REQUEST FOR PROPOSAL

Project Title: Cooley Laboratory Renovation
Location: Montana State University

PPA No.: 10-0023
RFP No.: 43
Date: May 15, 2012

Revise Mechanical Fence :

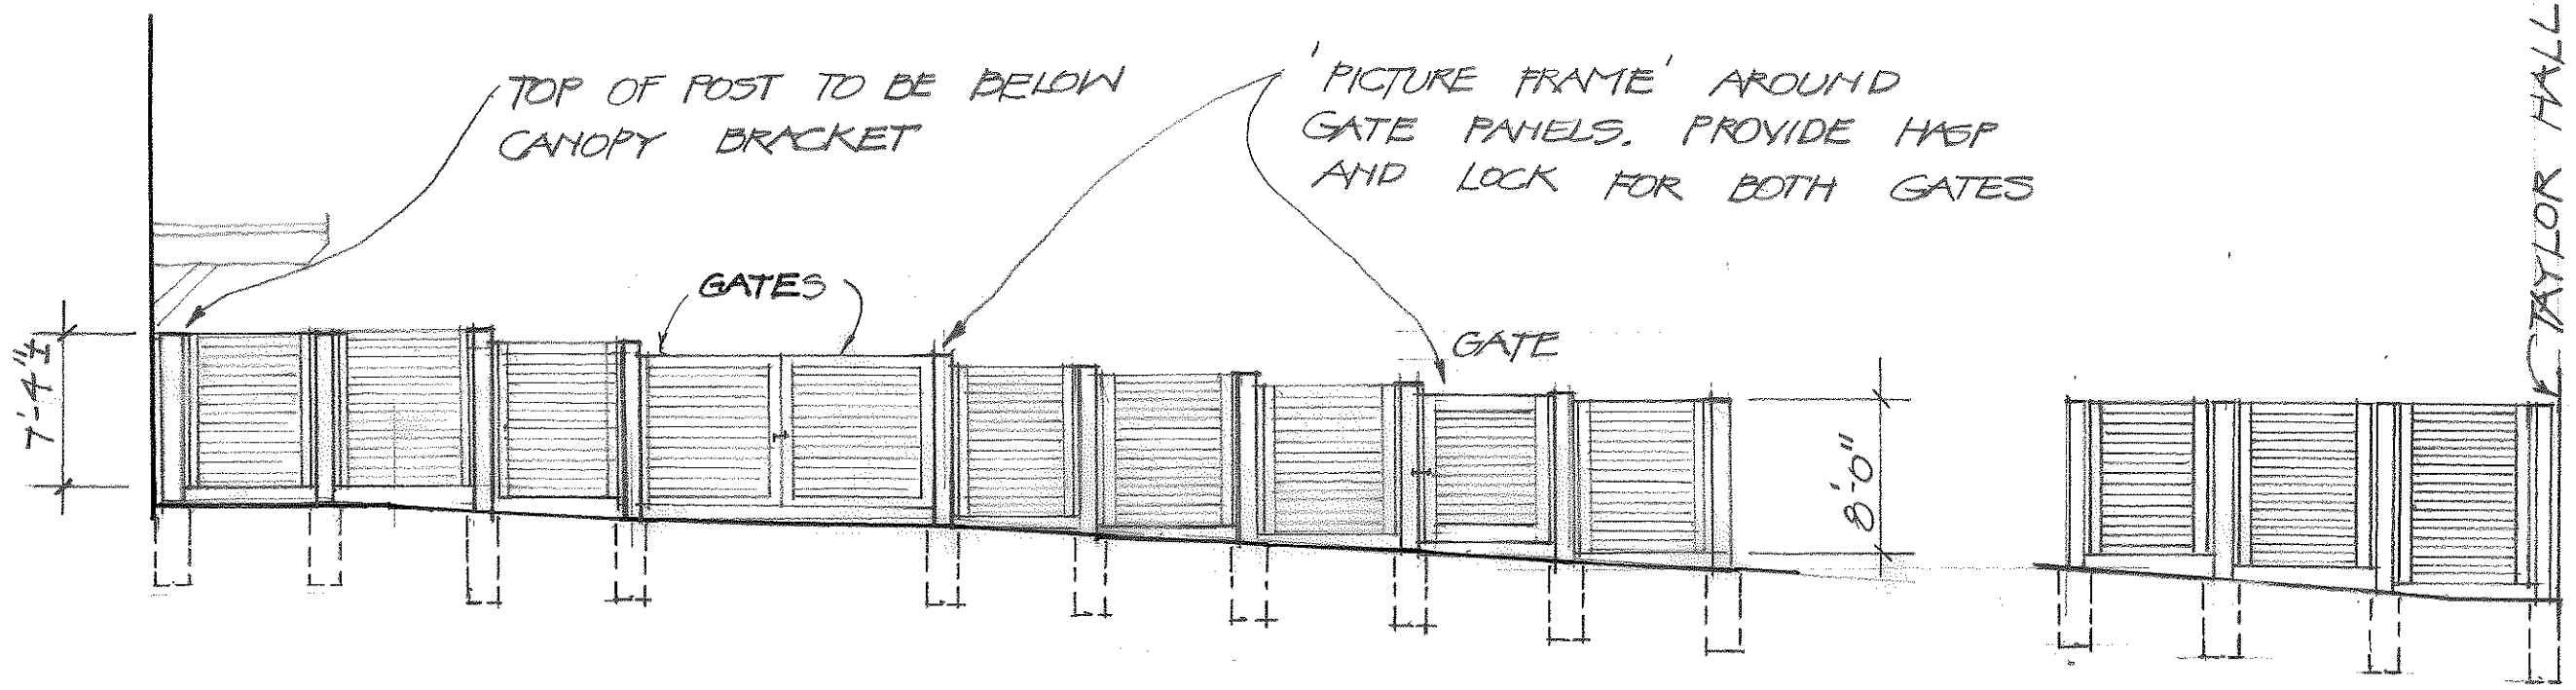
PER THE ATTACHED SKETCHES PROVIDE THE LOUVERED FENCE AS DESCRIBED ALL SECTIONS OF FENCE TO BE DEMOUNTABLE BY MECHANICAL FASTENERS.

GATES TO HAVE A LOCKABLE HASP

EAST ELEVATION  
COOLEY FENCE

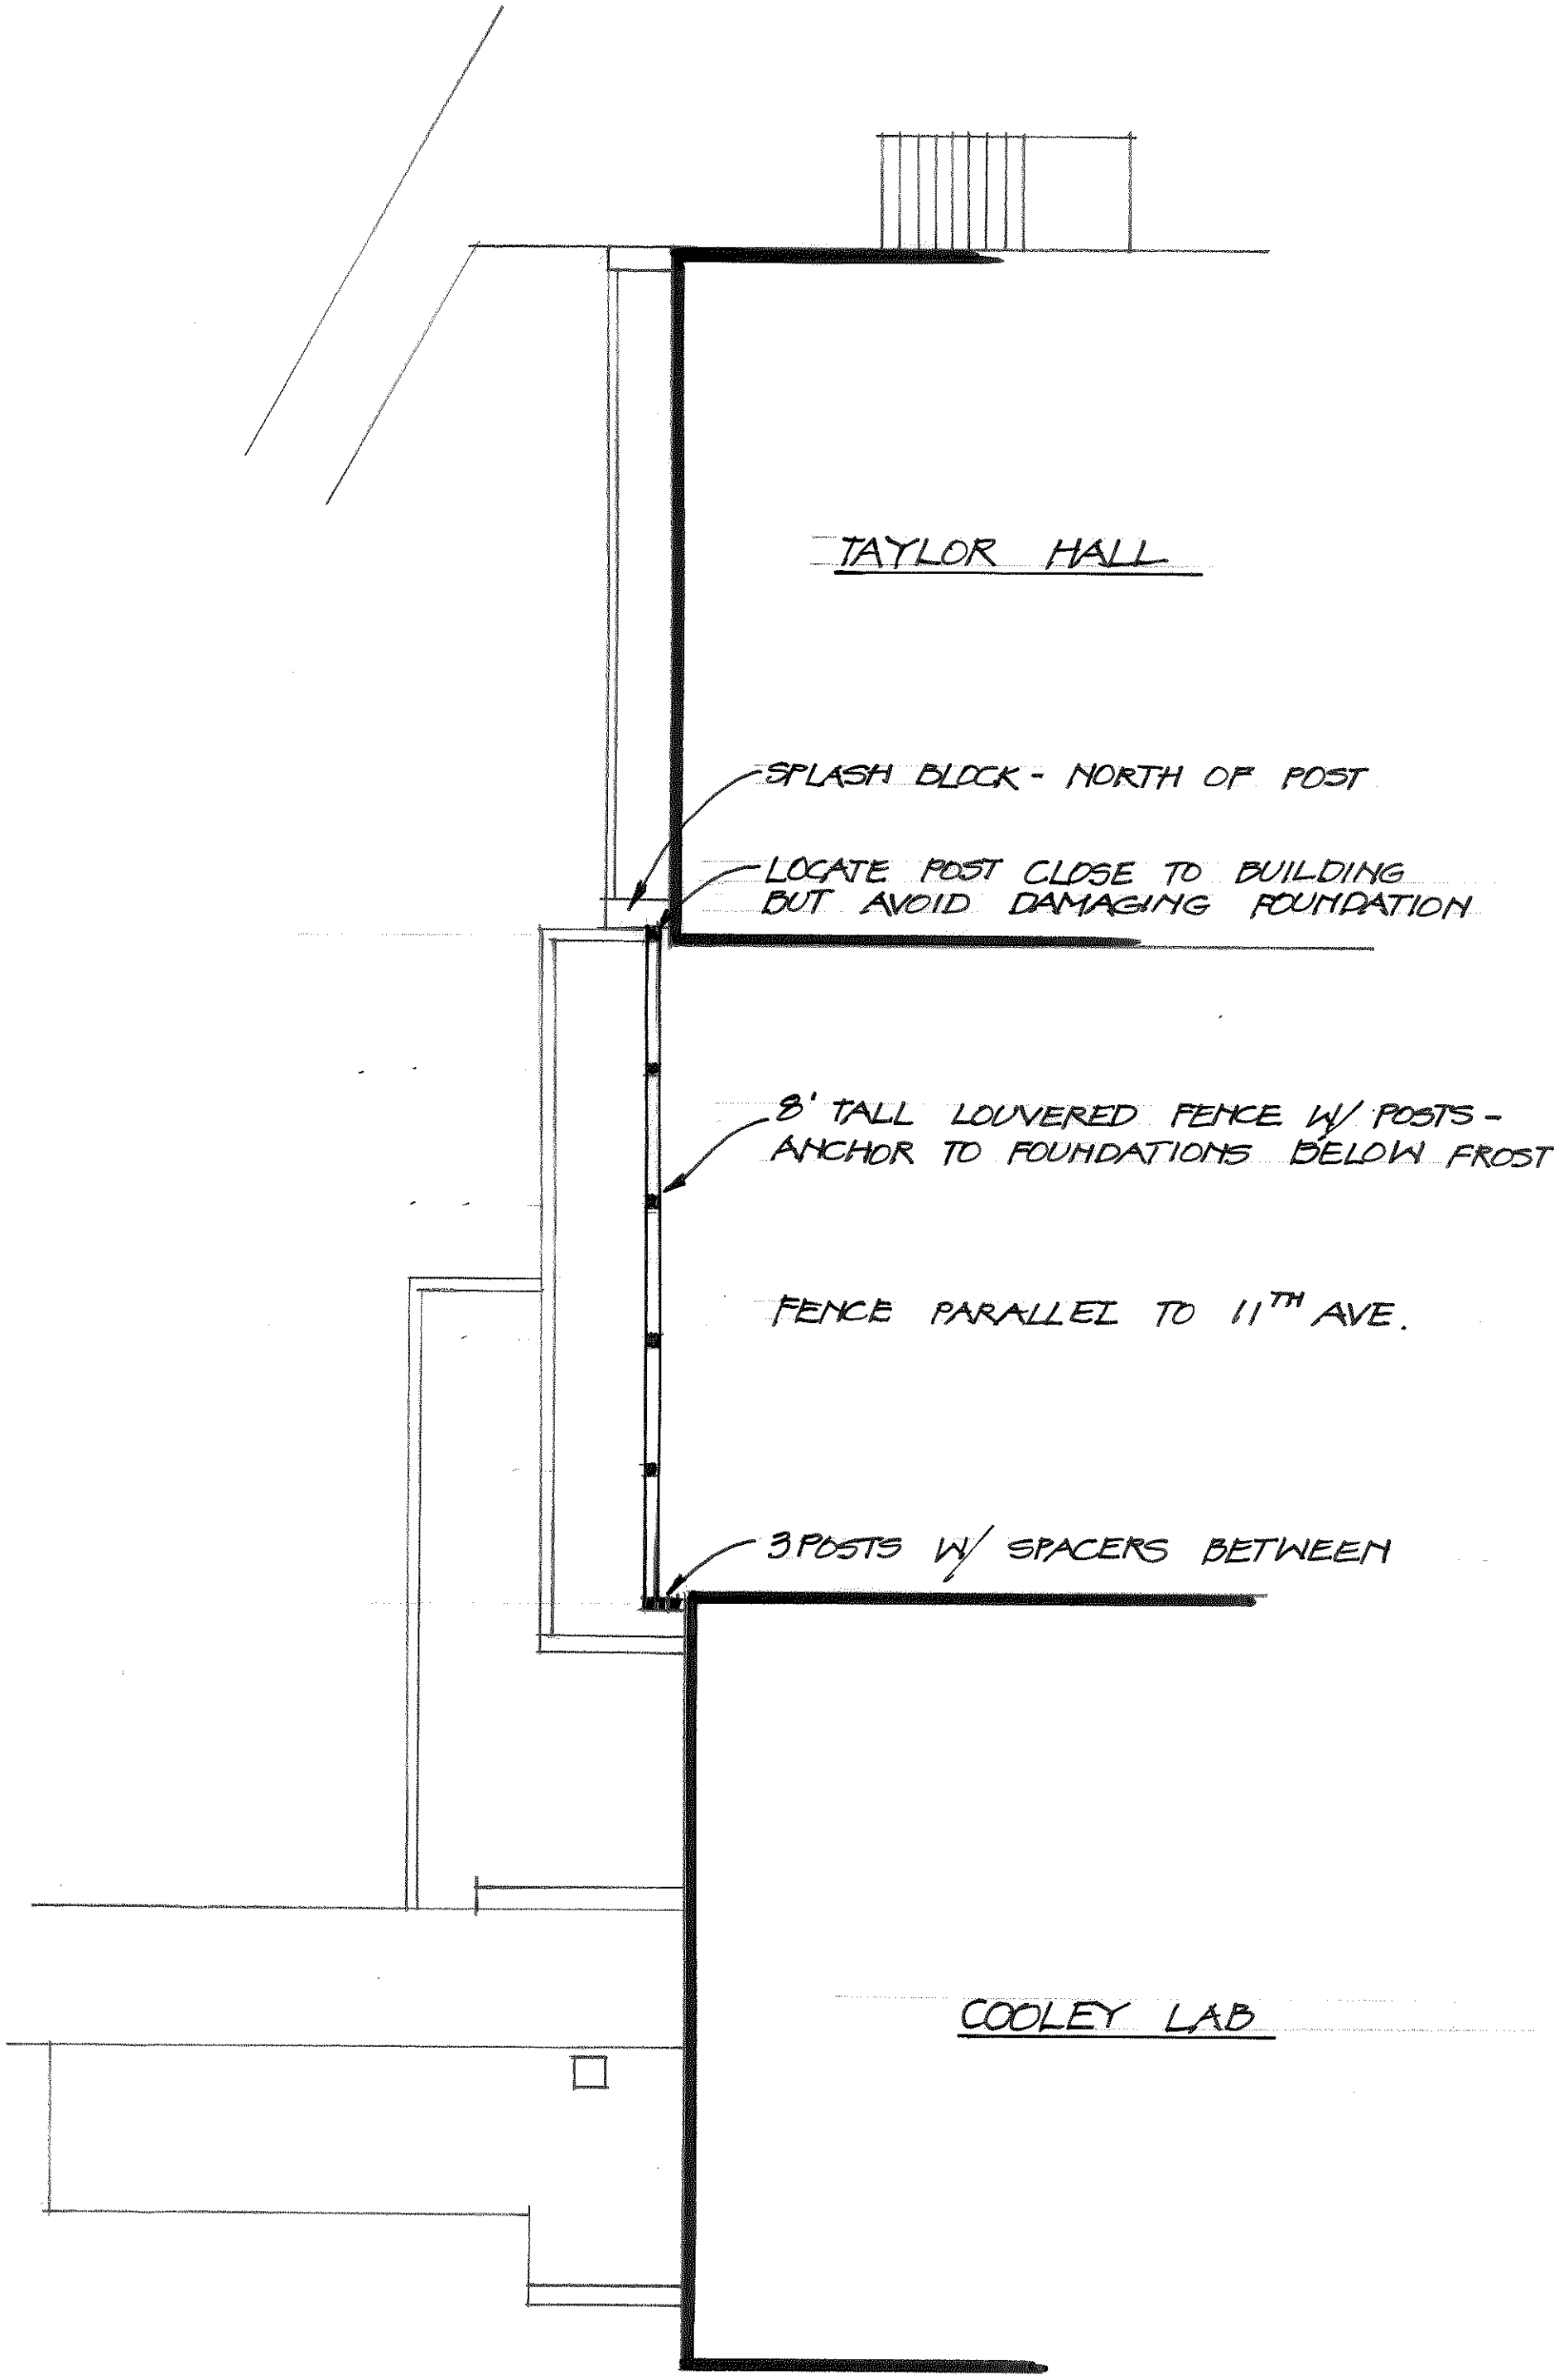
NOTE - ALL LOUVERS TO LINE-UP  
HORIZONTALLY BETWEEN PANELS

WEST FENCE

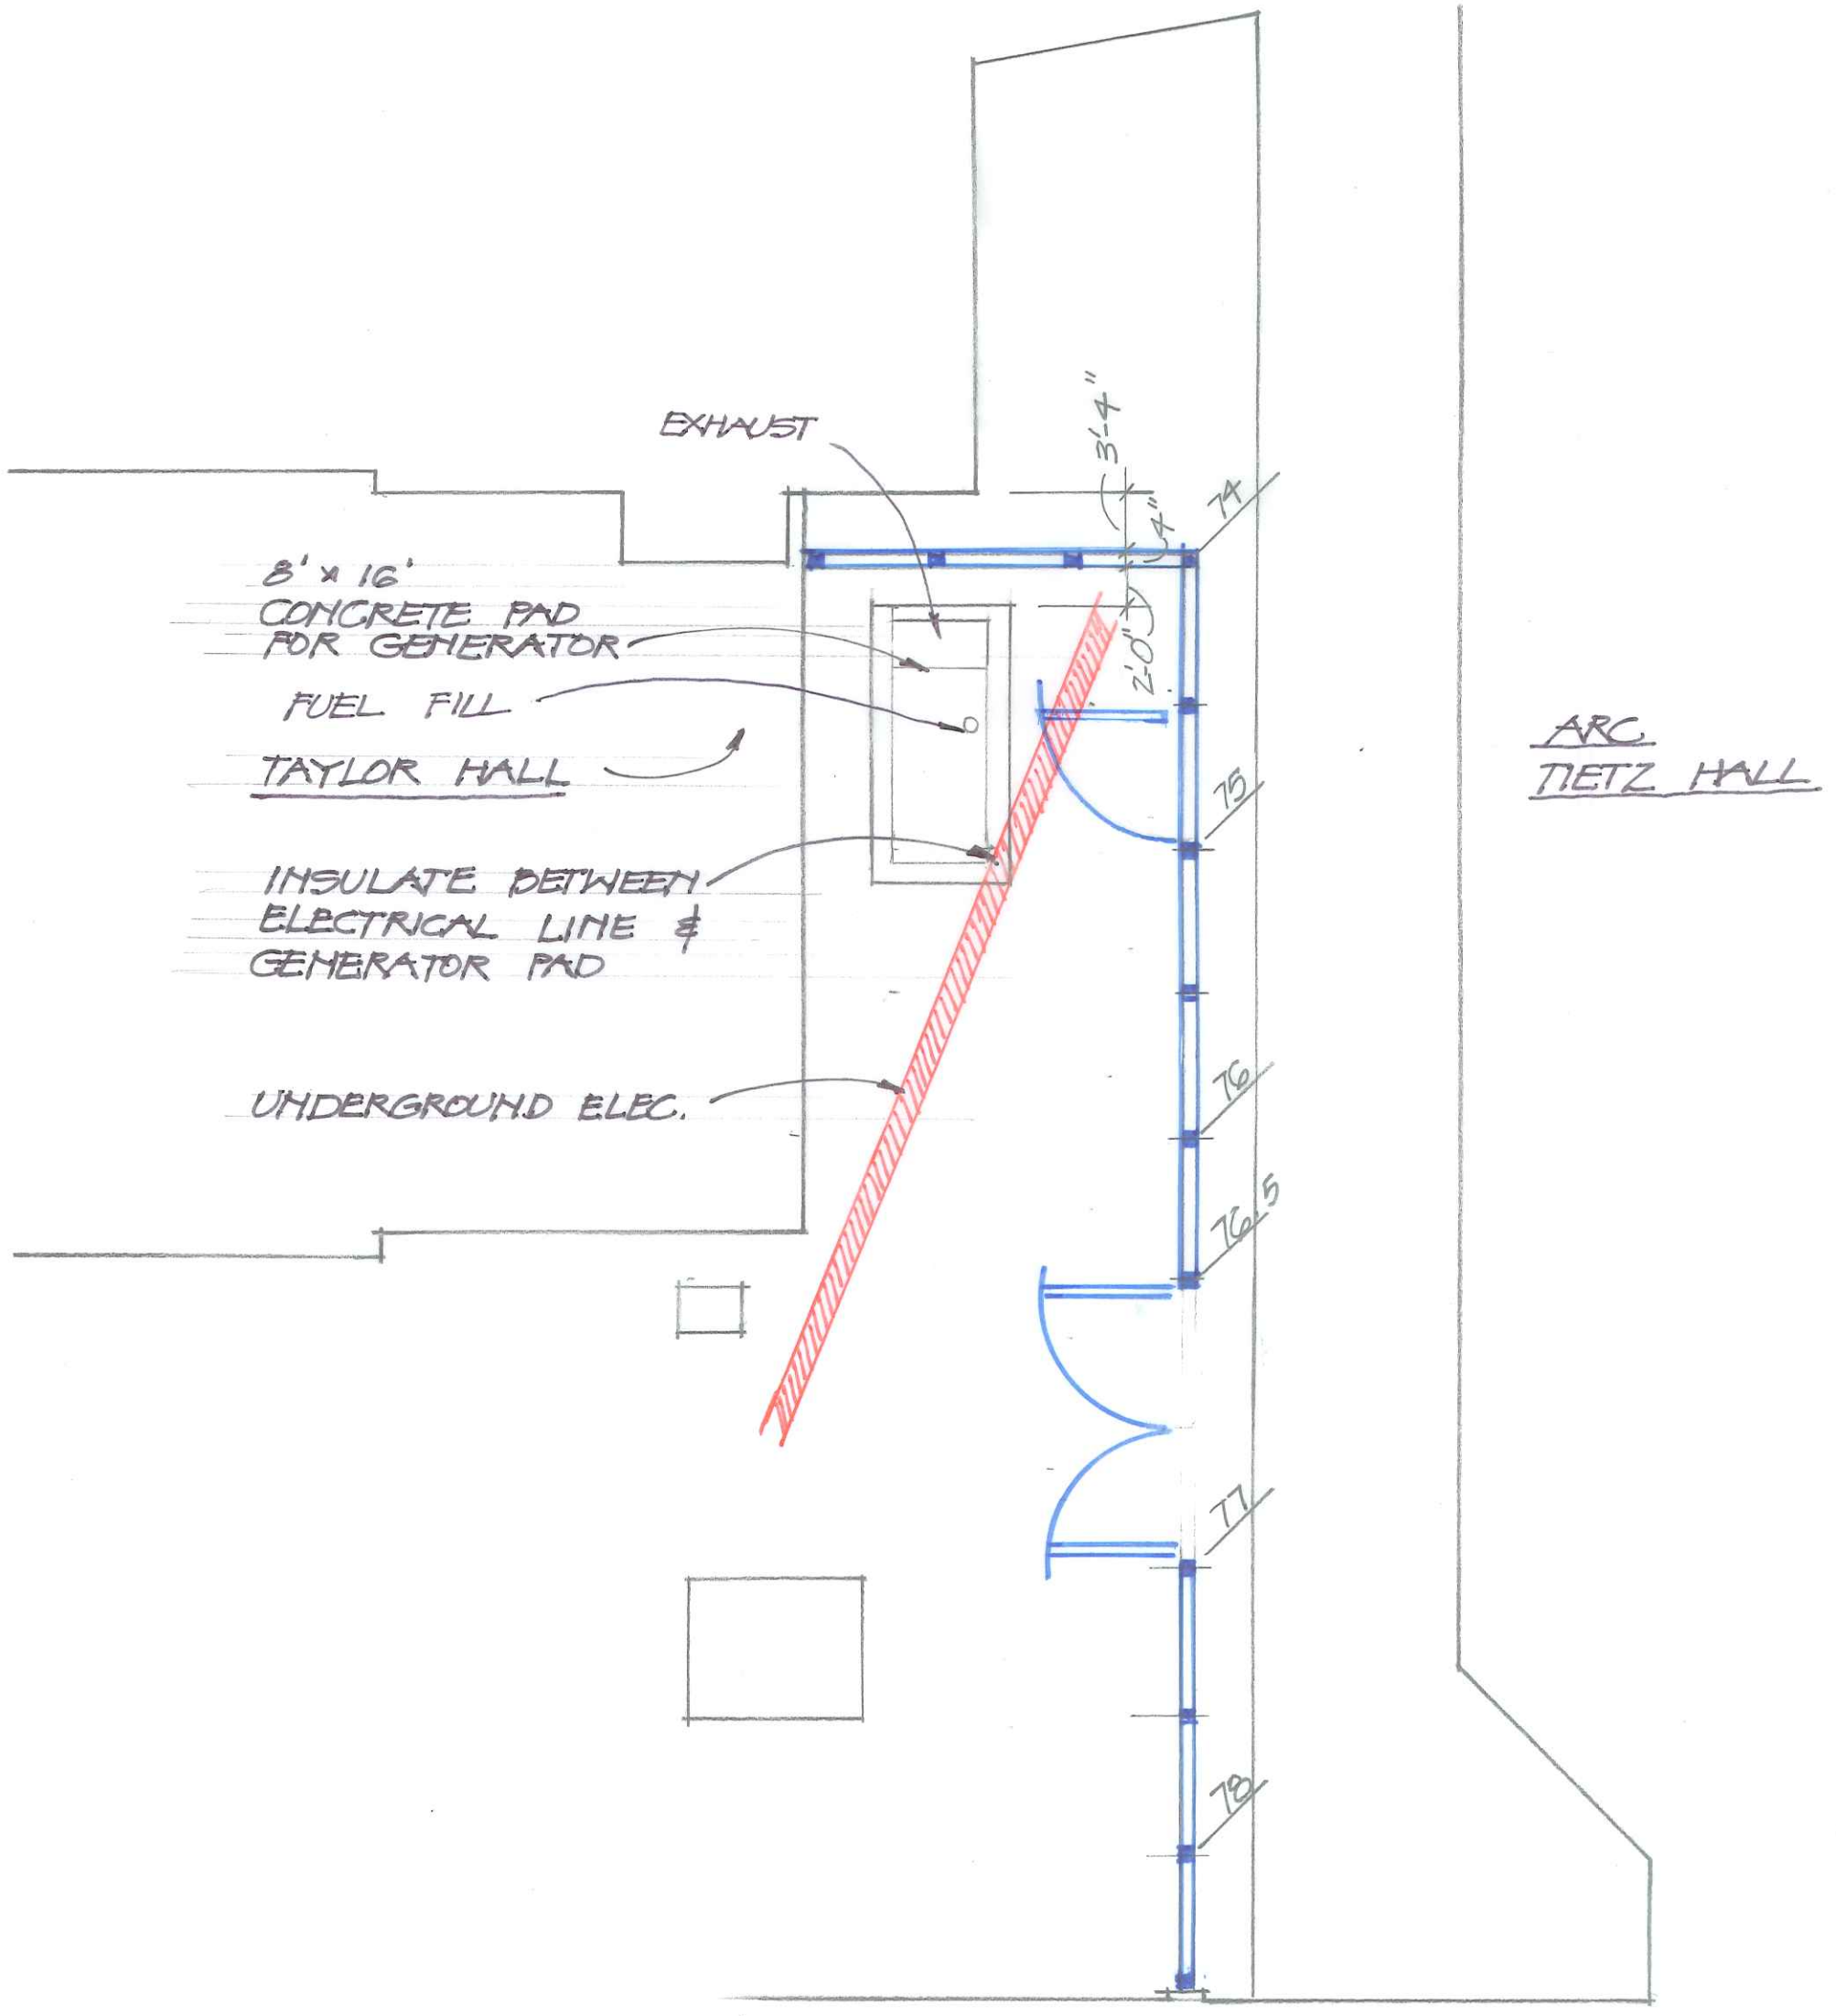
SPLASH BLOCK - NORTH OF POST

LOCATE POST CLOSE TO BUILDING  
BUT AVOID DAMAGING FOUNDATION

8' TALL LOUVERED FENCE W/ POSTS -  
ANCHOR TO FOUNDATIONS BELOW FROST

FENCE PARALLEL TO 11<sup>TH</sup> AVE.

3 POSTS W/ SPACERS BETWEEN

COOLEY LAB RENOVATION  
SITE PLAN

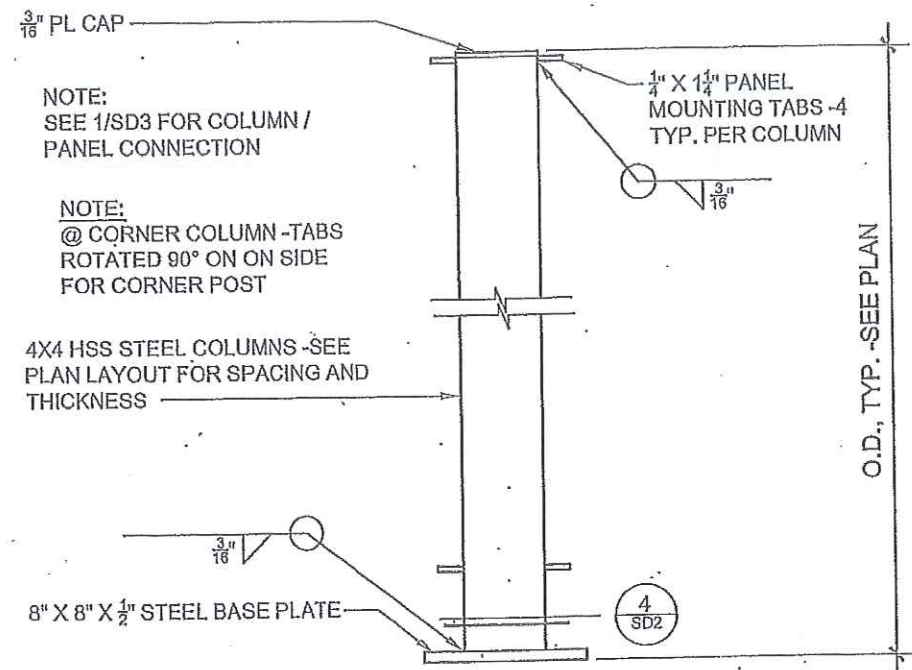
8' x 16'  
CONCRETE PAD  
FOR GENERATOR

INSULATE BETWEEN  
ELECTRICAL LINE &  
GENERATOR PAD
